77 Walnut St. Portland, ME

Amendment to Foundation repair permit: Repair upper deck framing and deck boards.

By: Eric Favreau
Spinnaker Carpentry LLC

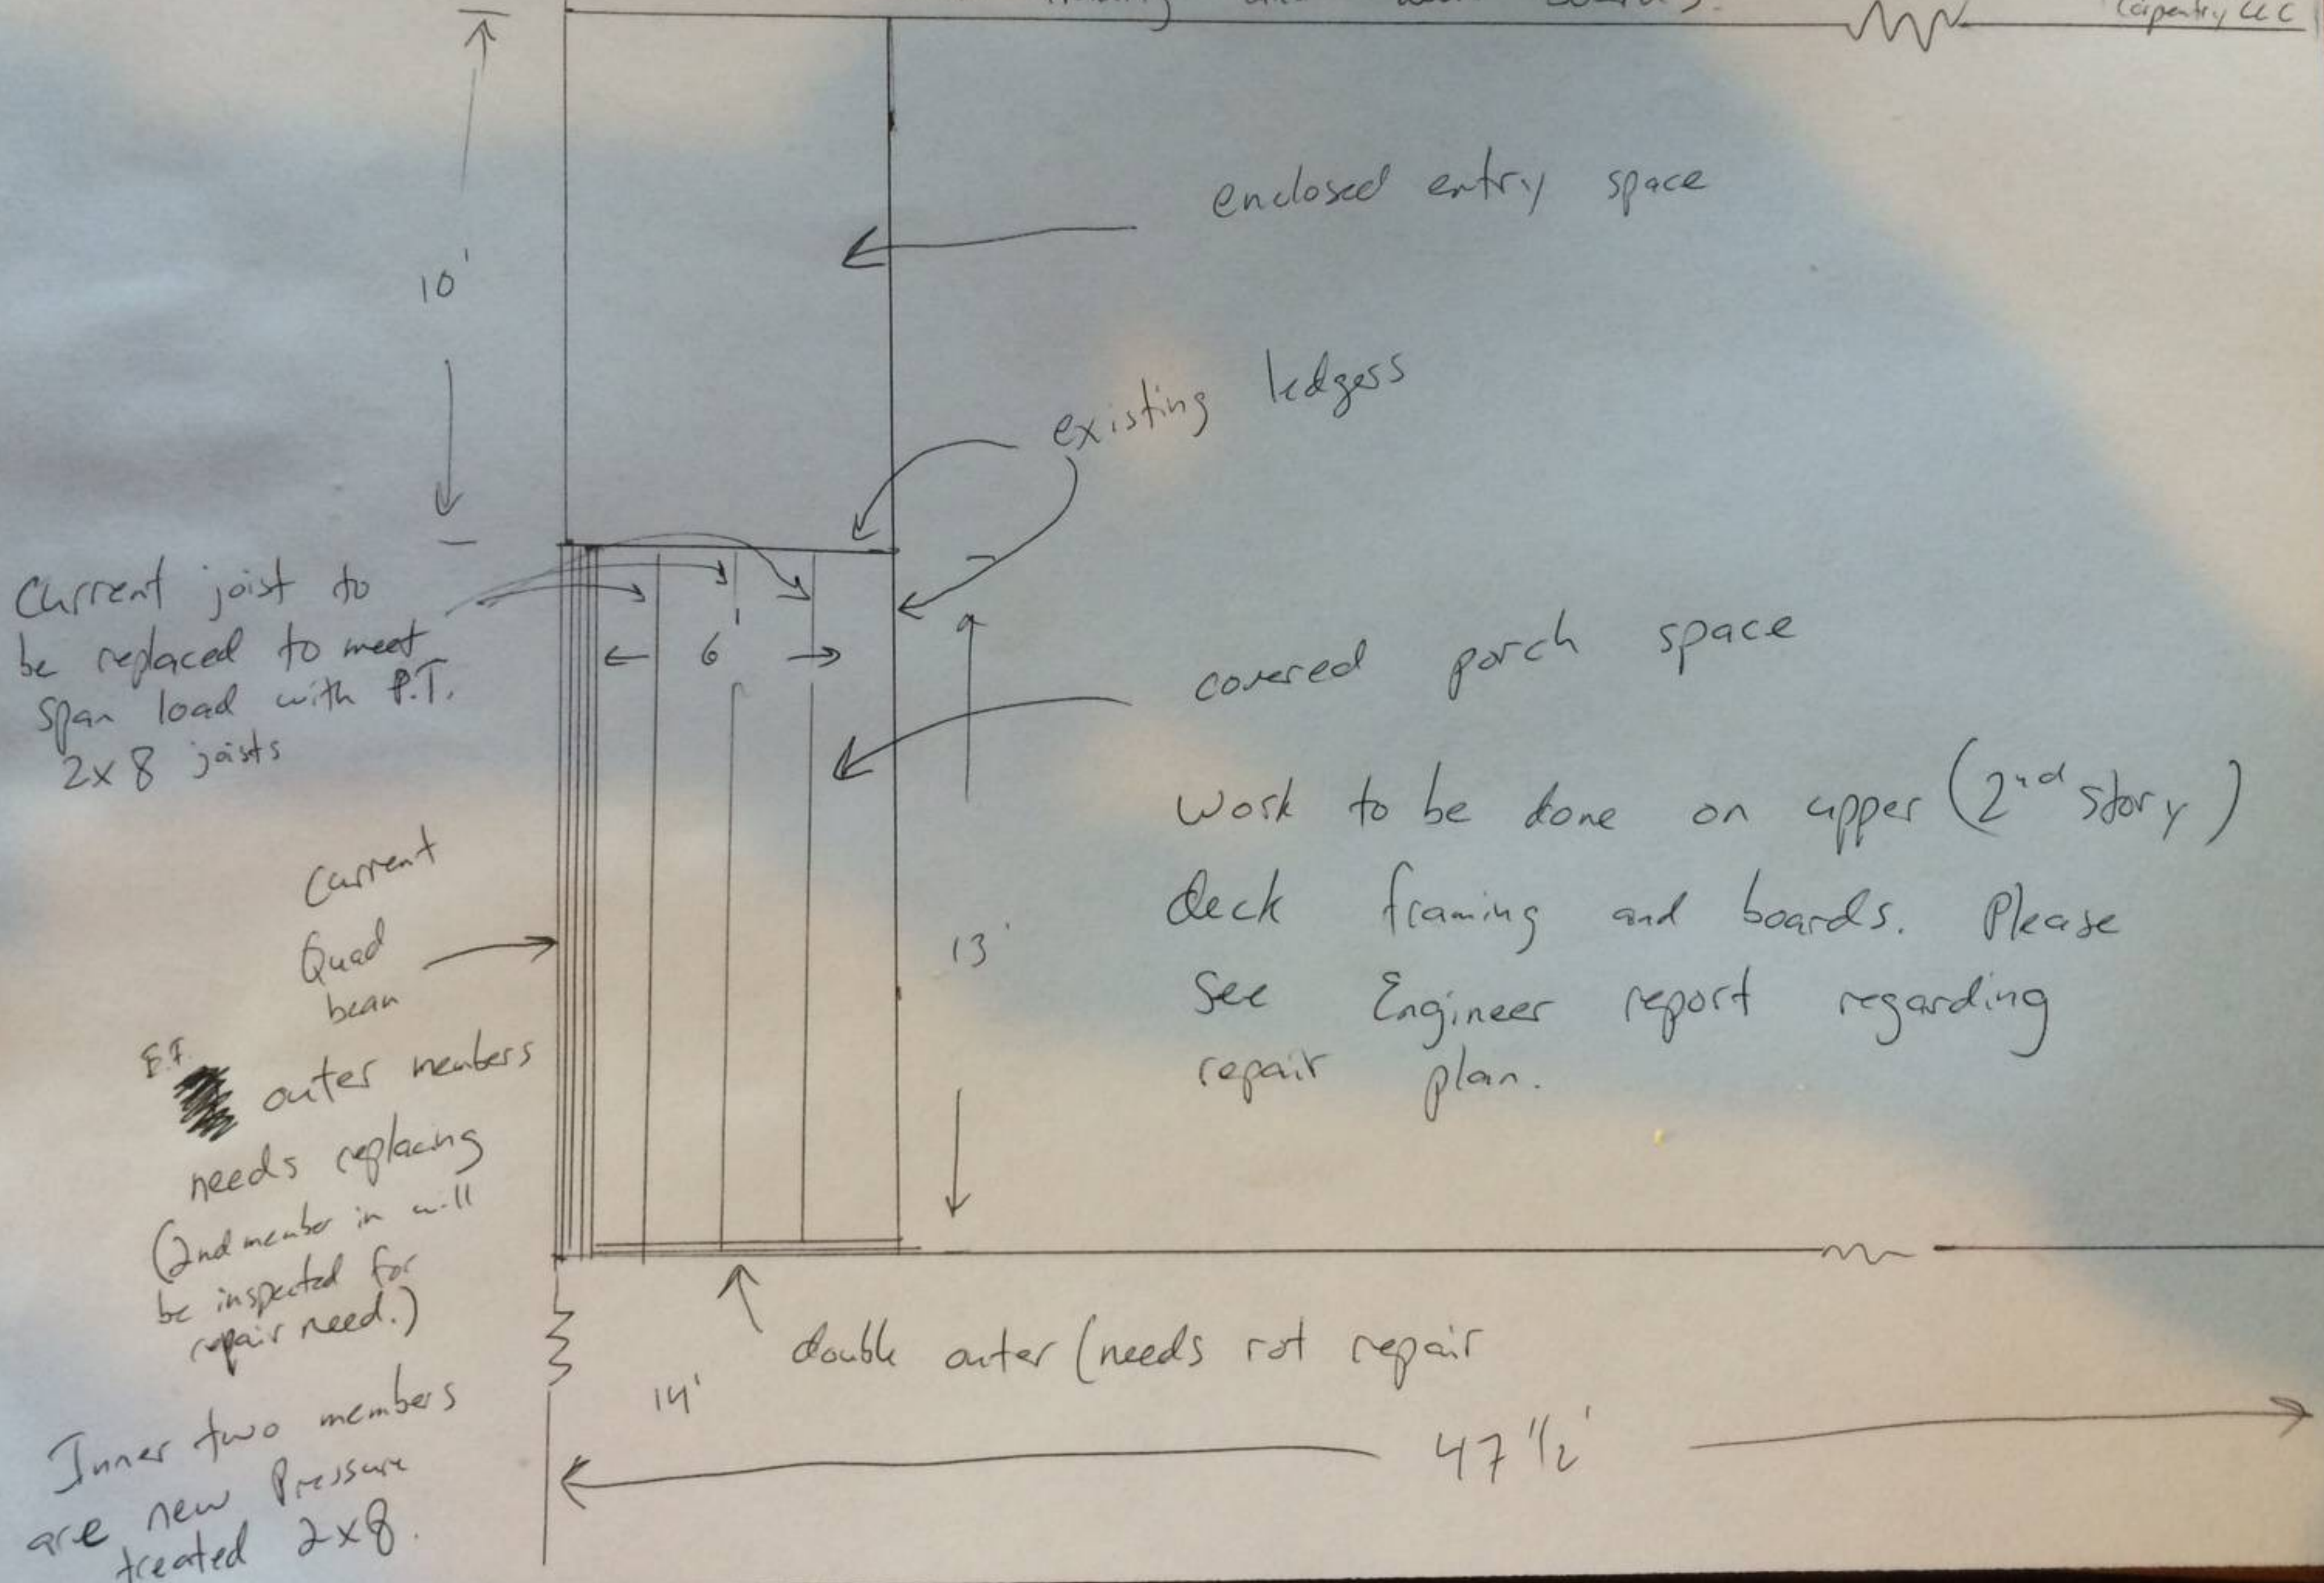
Current joist to be replaced to meet span load with P.T. 2x8 joists

Work to be done on upper (2nd story) deck framing and boards. Please see Engineer report regarding repair plan.

Current Quad beam
E.F. outer members needs replacing (2nd member in will be inspected for repair need.)

Inner two members are new Pressure treated 2x8.

double outer (needs rot repair)
